Chelsea
Community
Hospital

RE: Amendment to NRC License 21-20355-01
Chelsea Community Hospital

The purpose of this letter is to amend our current NRC license to reflect the following changes:

Nuclear Medicine Department

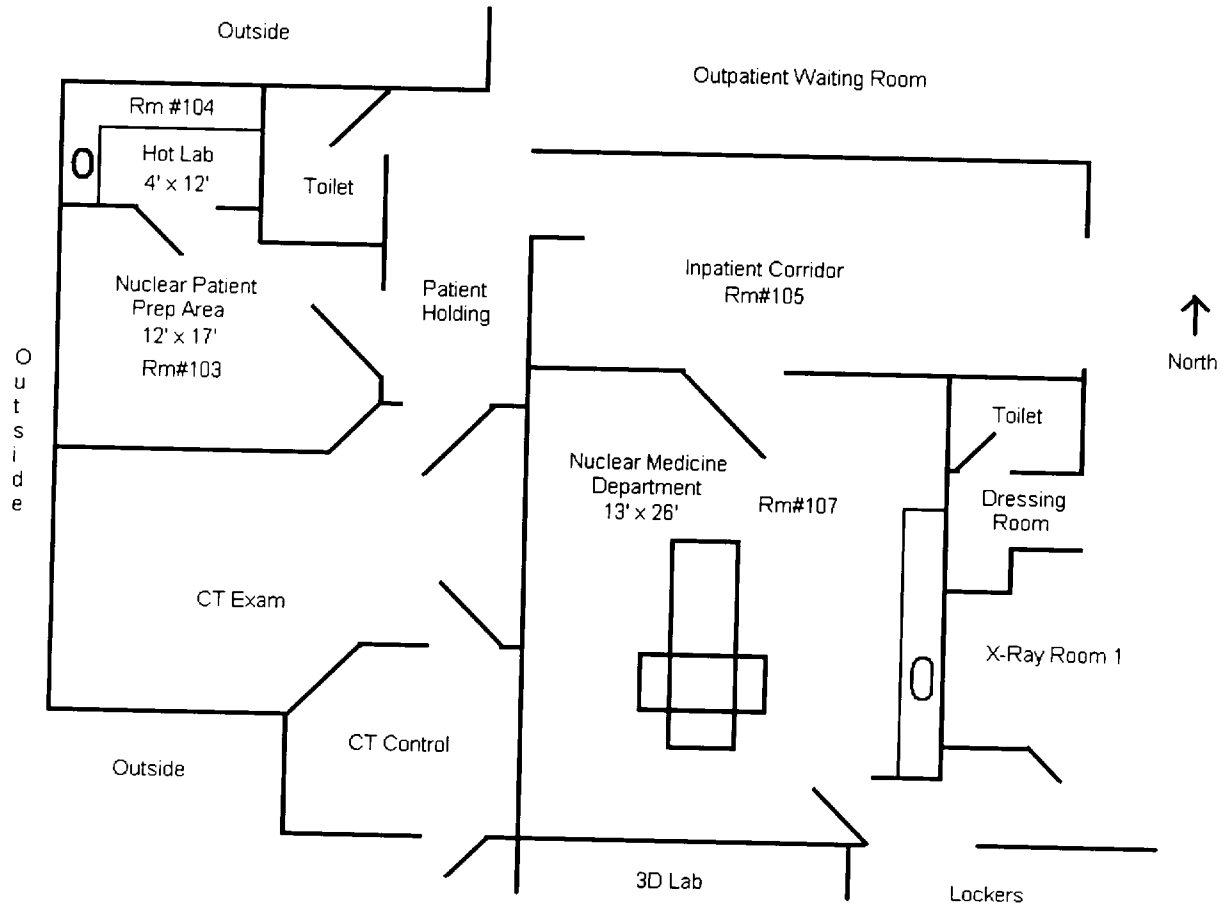
Please find the enclosed diagram for the remodeling of our facility.

- Please note the north direction, room dimensions, and room numbers are listed on the enclosed area diagram.
- The door to the hot lab will be under lock and / or key at all times. Only nuclear medicine technologists and the RSO will have access to the keys and/or combination to the hot lab.

Directly below the nuclear medicine department is the earth.
Directly above the nuclear medicine department is the roof.
